re: Geotechnical Review - McKinnon's Creek Alterations
Proposed residential Development
Summerside West - Tenth Line Road - Ottawa

to:David Schaeffer Engineering Limited - **Ms. Jennifer Ailey** - jailey@dsel.ca
to:David Schaeffer Engineering Limited - **Mr. Steve Pichette** - spichette@dsel.ca
to:Mattamy Homes - **Ms. Jillian Normand** - Jillian.Normand@mattamycorp.com
date:November 26, 2018
file:PG4049-MEMO.10 Revision 2

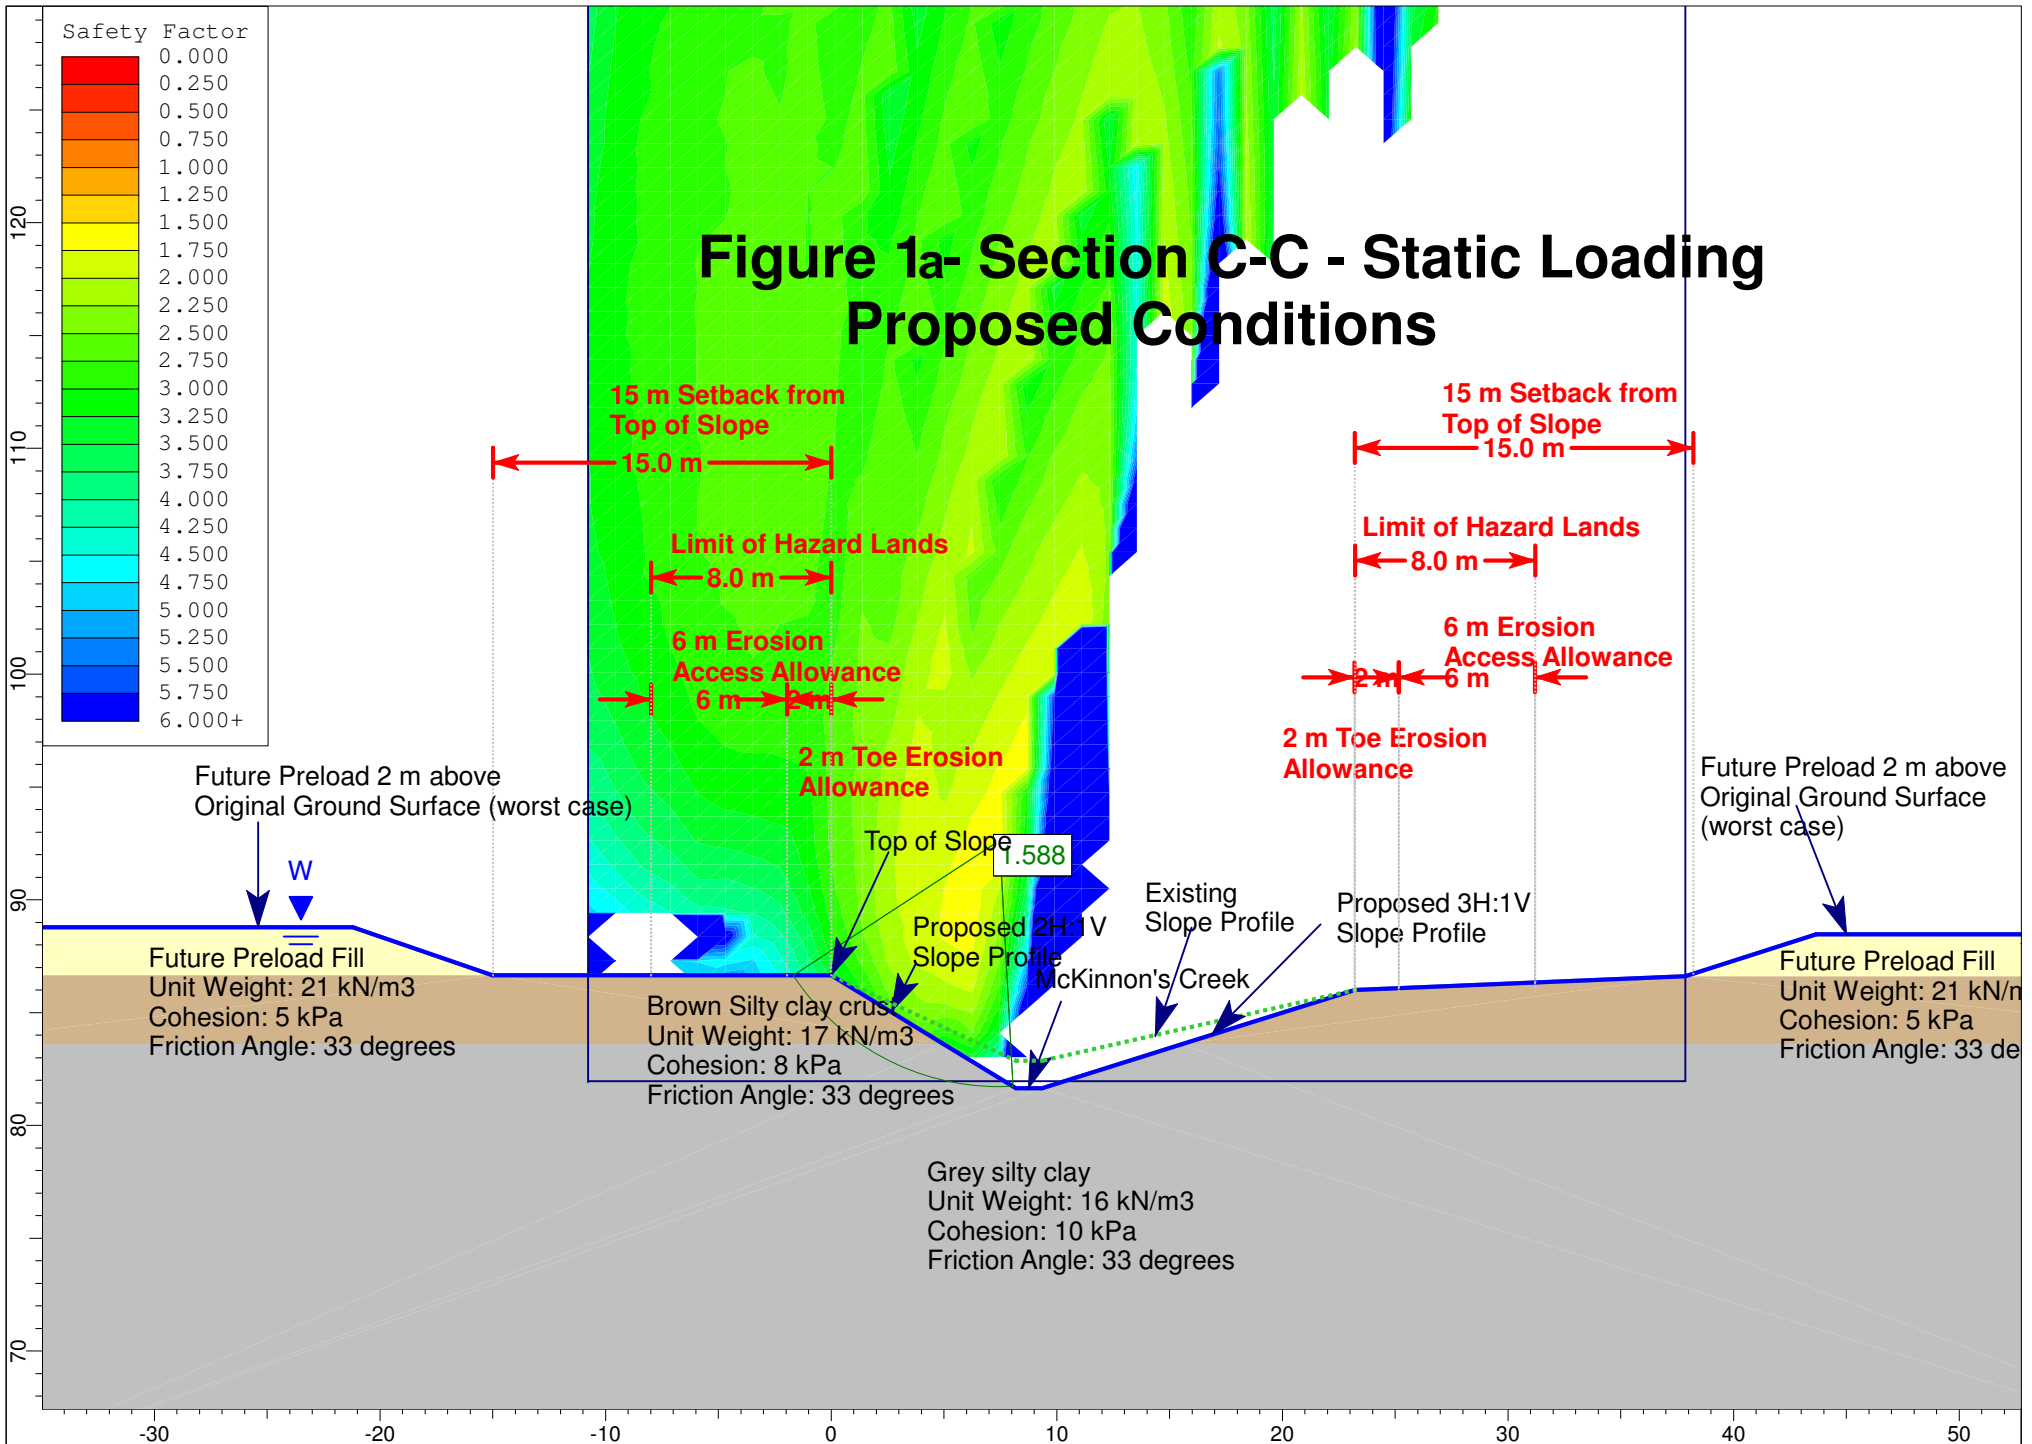
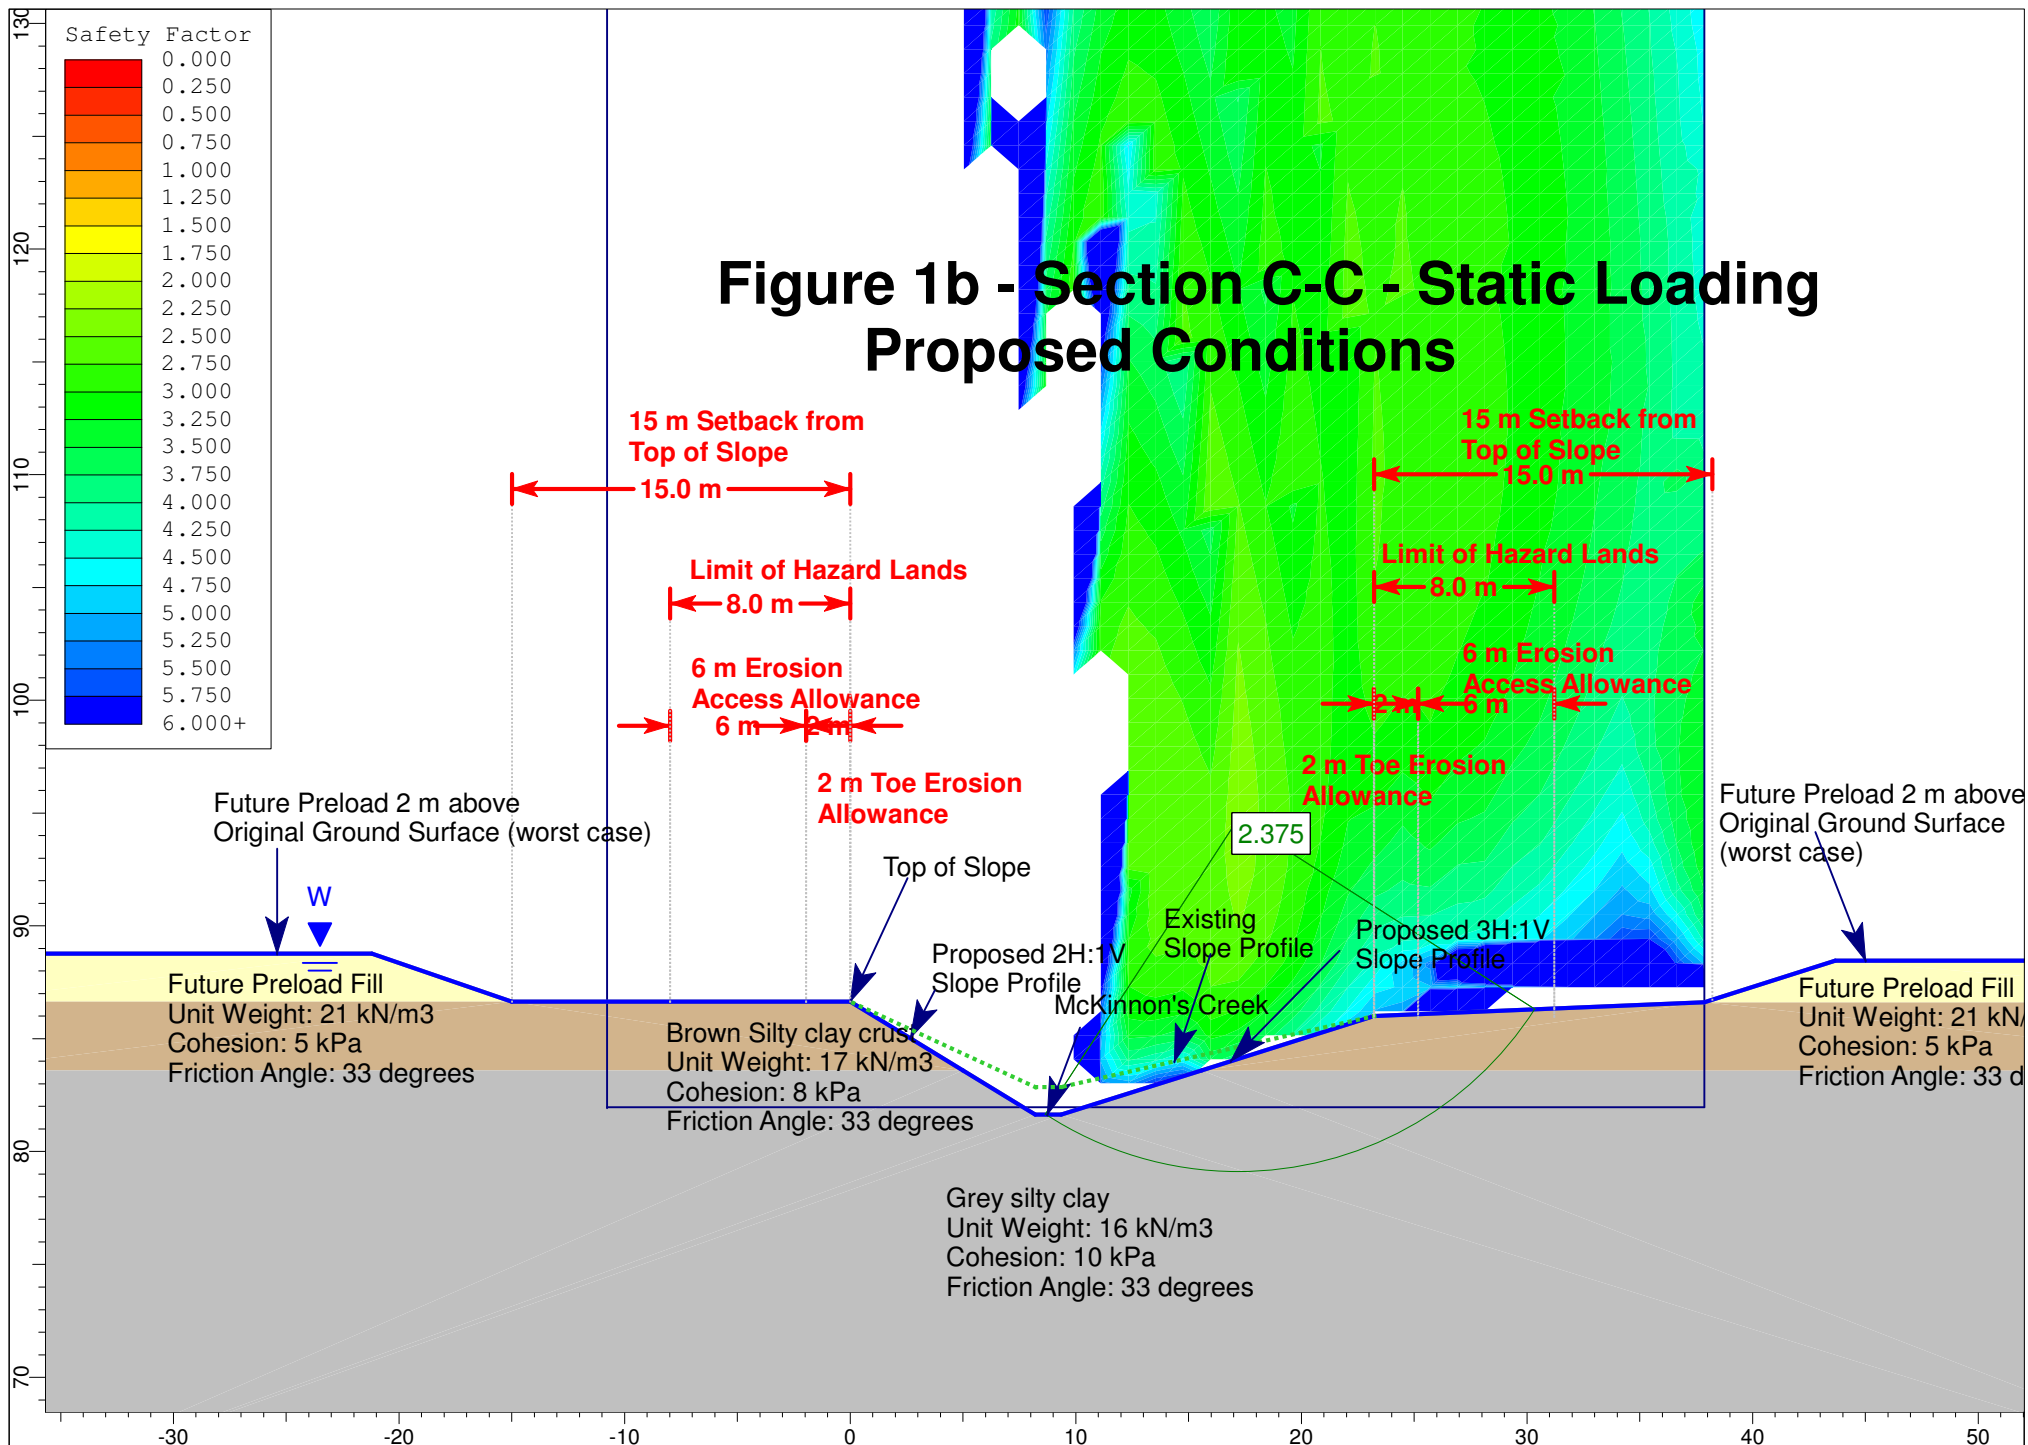
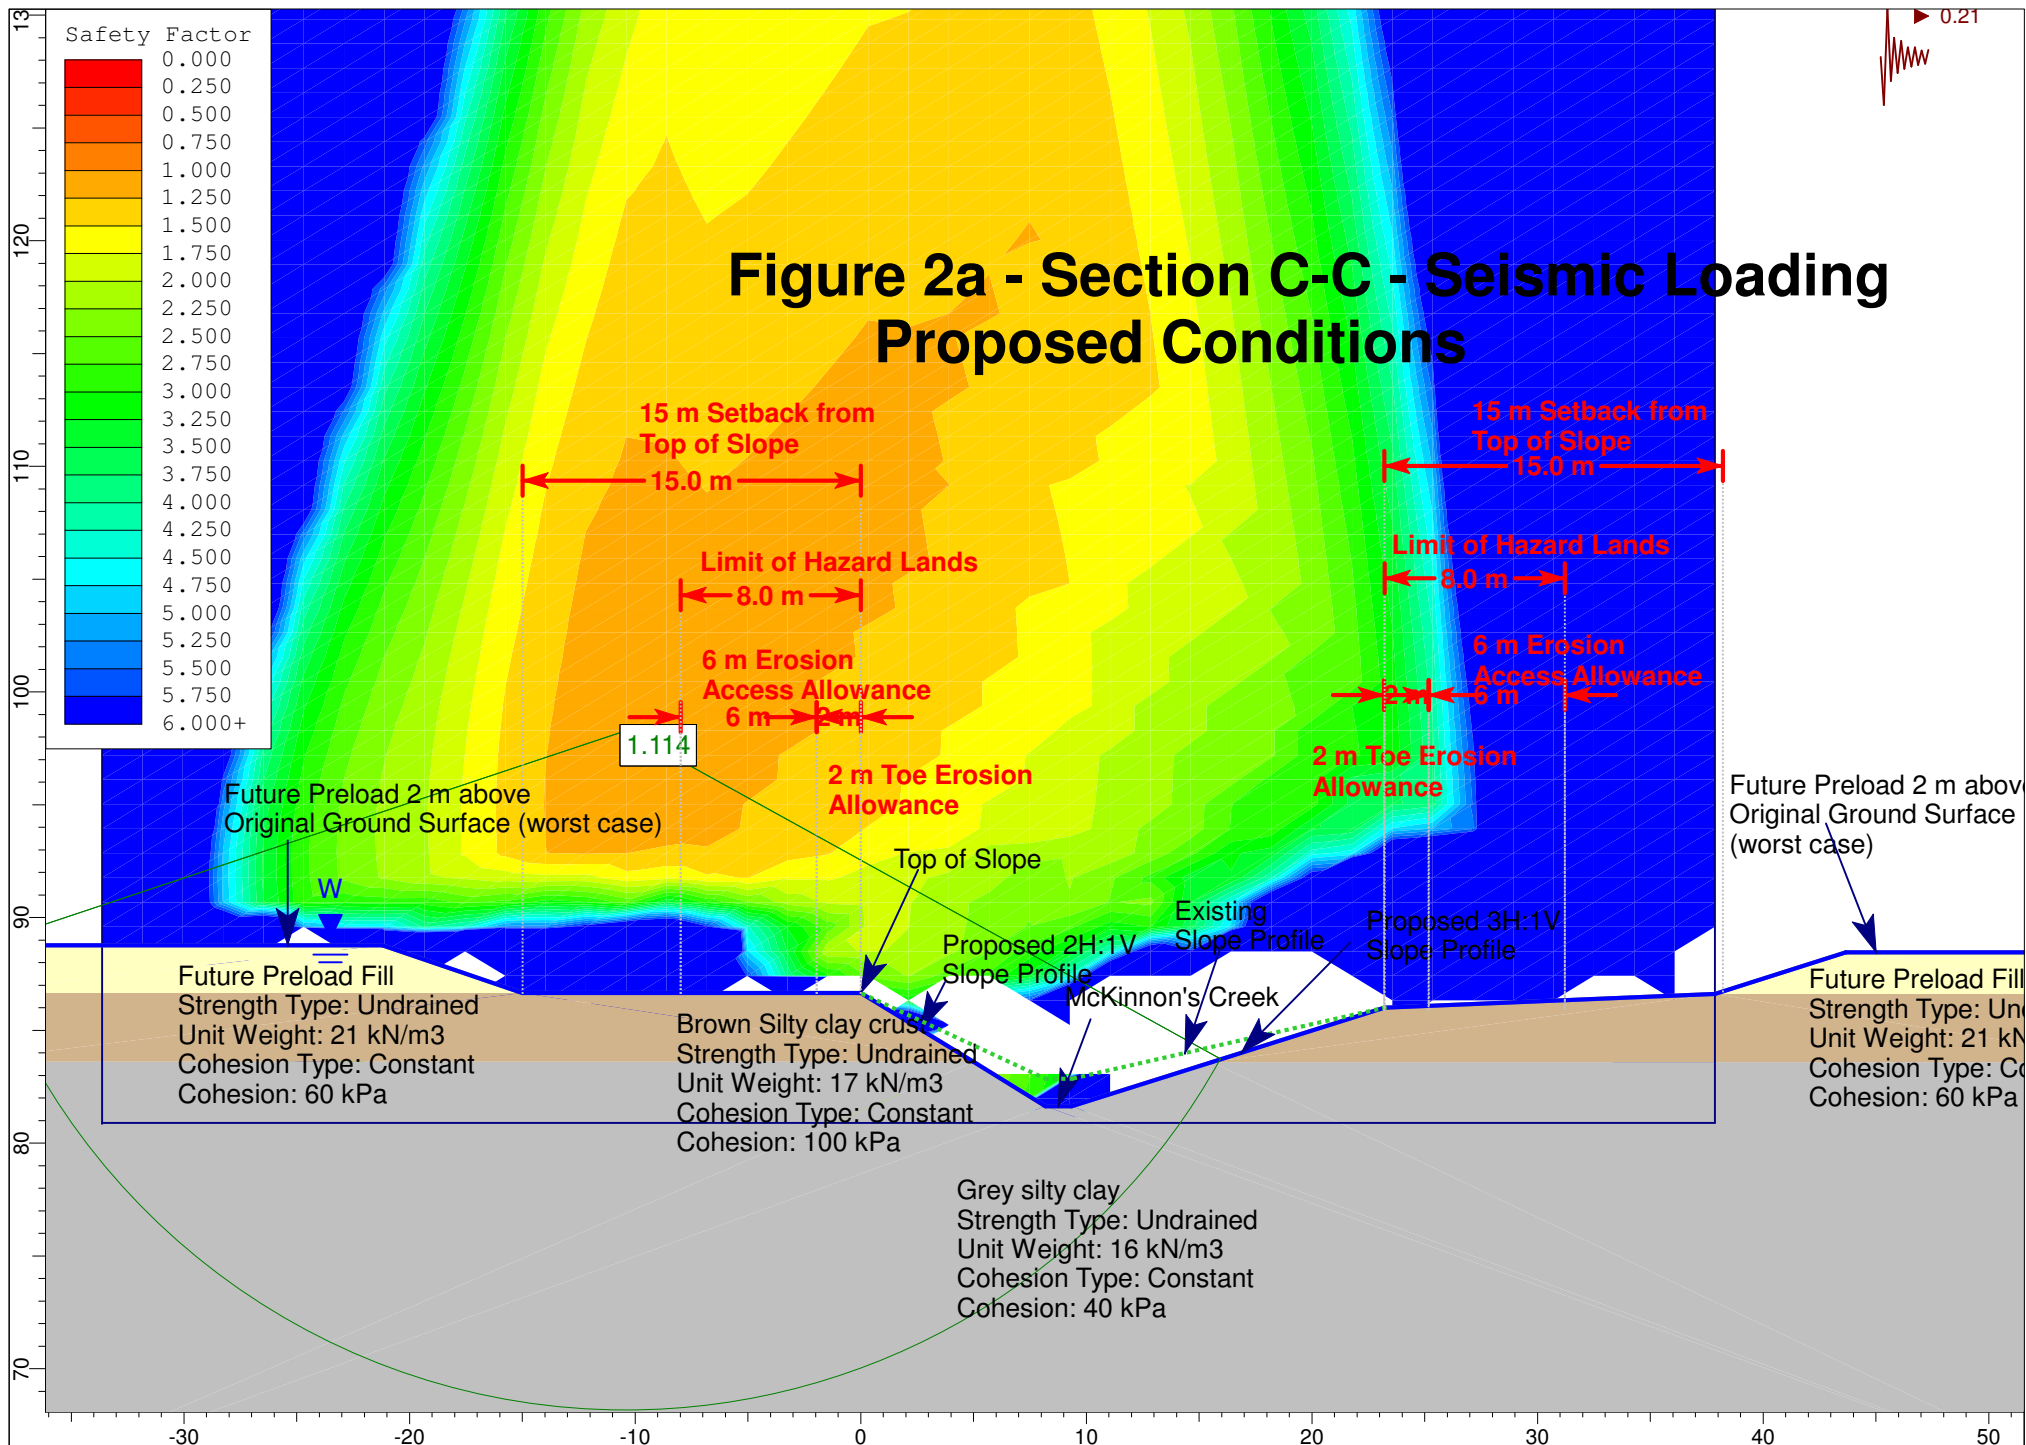
The results of our analysis are presented in Figures 1a, 1b, 2a and 2b attached. Figures 1a and 1b present the results of our global slope stability analysis under static conditions for each side slope of the channel and Figures 2a and 2b present the analysis when considering the seismic loading. Based on our analysis results, Section C-C is considered stable with a global slope stability factor of safety of greater than 1.5 under static conditions and greater than 1.1 under seismic loading. Therefore, a slope stability setback is not required for the limit of hazard lands setback.
